QUALITY ASSURANCE -- NON-CONFORMANCE REPORT

Location: Changxing Island, Shanghai, P.R. China **Report No:** NCR-000393
Prime Contractor: American Bridge/Fluor Enterprises, a JV **Date:** 19-Aug-2009
Submitting Contractor: Zhenhua Port Machinery Company, Ltd (ZPMC), Changxing Island **NCR #:** ZPMC-0367

Reference Description: Missed MT transverse indication by QC on OBG Floorbeam 24

Job Name: SAS Superstructure

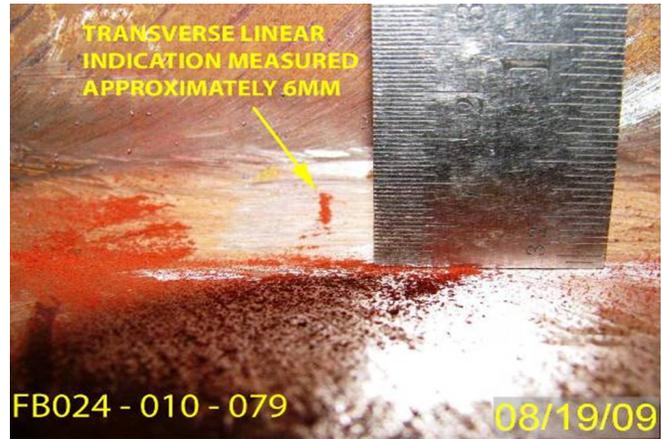
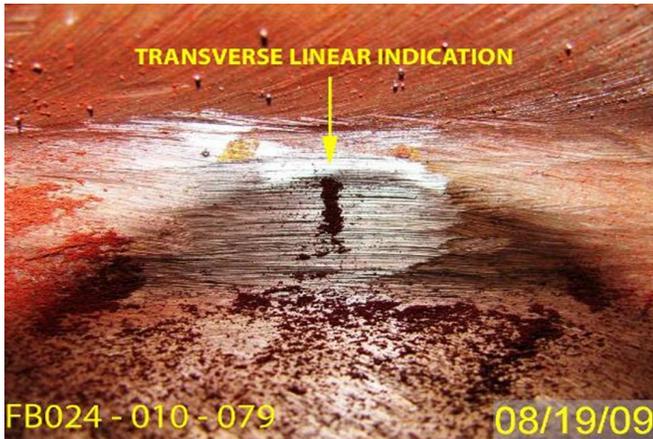
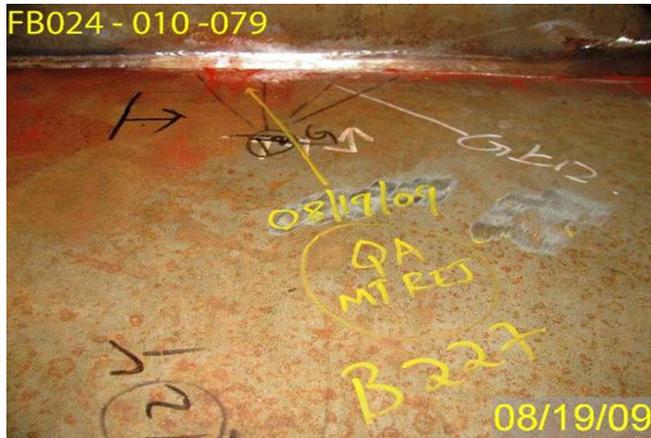
During random verification Magnetic Particle Testing (MT) for the OBG Floor Beam at Bay # 3, this Caltrans Quality Assurance Inspector (QA) observed one (1) transverse linear indication approximately 6mm in length in the weld metal on FB024-010-079. This area has been previously tested and accepted by ZPMC MT Technician.

AWS D1.5 (02) Section 6.26.2 – “Welds that are subject to MT in addition to visual inspection shall have no cracks.

Reference Resolution: The indication was removed with grinding. ZPMC is submitting NDT documents to show that the weld is acceptable.

Documentation recieved for the repair is correct and therefore this NCR is closed. It should be noted however that the NCR has an error referencing the 79 weld when in fact it was the 99 weld. The letter of response does not reference the correct NCR.
